### **REGULAR MEETING OF THE PLANNING COMMISSION**

**Monday, August 05, 2024**

A. Site Plan Review: VLO-24-02 (44 E. Flint) Mixed-Use Development

**Subject: VLO-24-02 44 E. Flint, Site Plan Review #2**

DRAWING:  
**C-5**

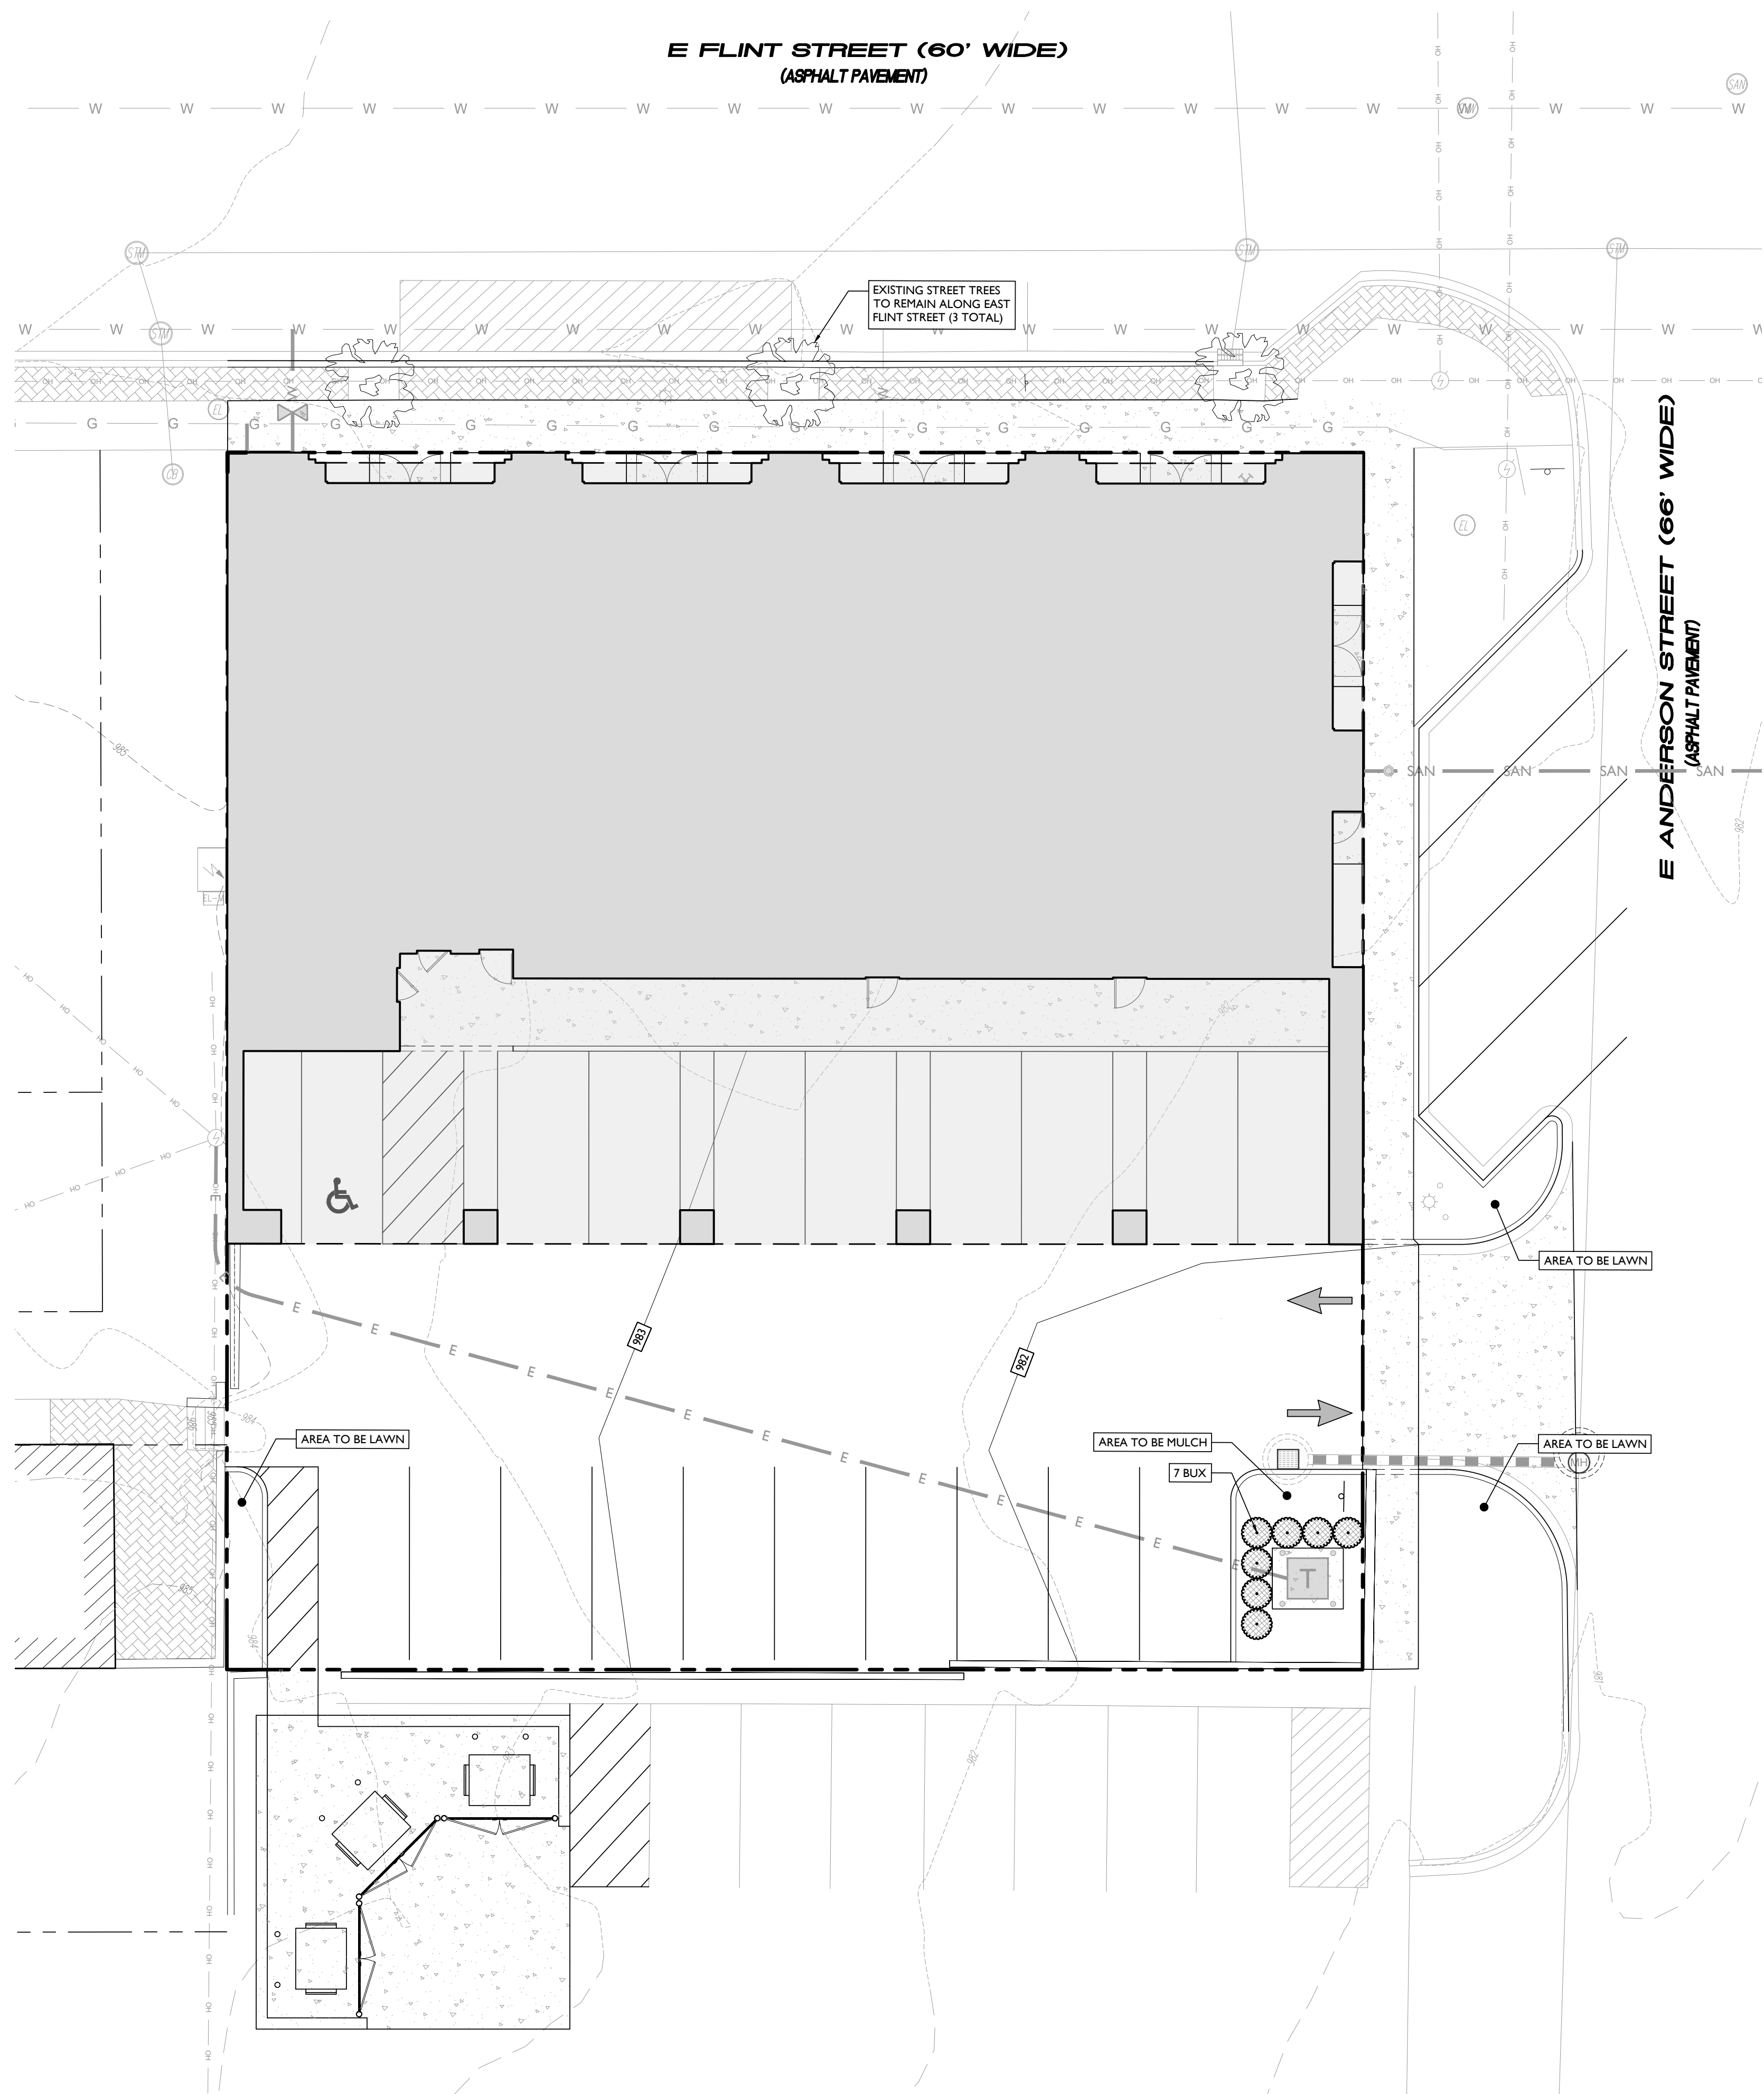
- 10. The proposed trash enclosure indicates a 6' masonry wall along three sides with gates in the front. Provide details and cross section.
- 11. The proposed water service line is shown connecting to a 6" water main in Flint Street. This line is abandoned. The correct connection would be to the 12" main shown on the survey.

- 12. The nearest hydrant is now shown as required, located at the SE corner of Flint and Anderson.
- 13. We note that the engineering site plans and architectural site plans are not completely consistent with one another, in particular at the southwest corner of the site where access to the trash enclosure is proposed and at the power pole on the west property line, where architectural plans call for its relocation. This pole is located offsite; any offsite work will require a temporary construction easement from the affected parcel(s).

**All proposed site utilities are indicated. Please refer to Sheet C-5 of the Site Development Plans.**

**A fire department connection has been provided on the building and the dimension to the nearest fire hydrant is shown. Please refer to Sheet C-5 of the Site Development Plans.**
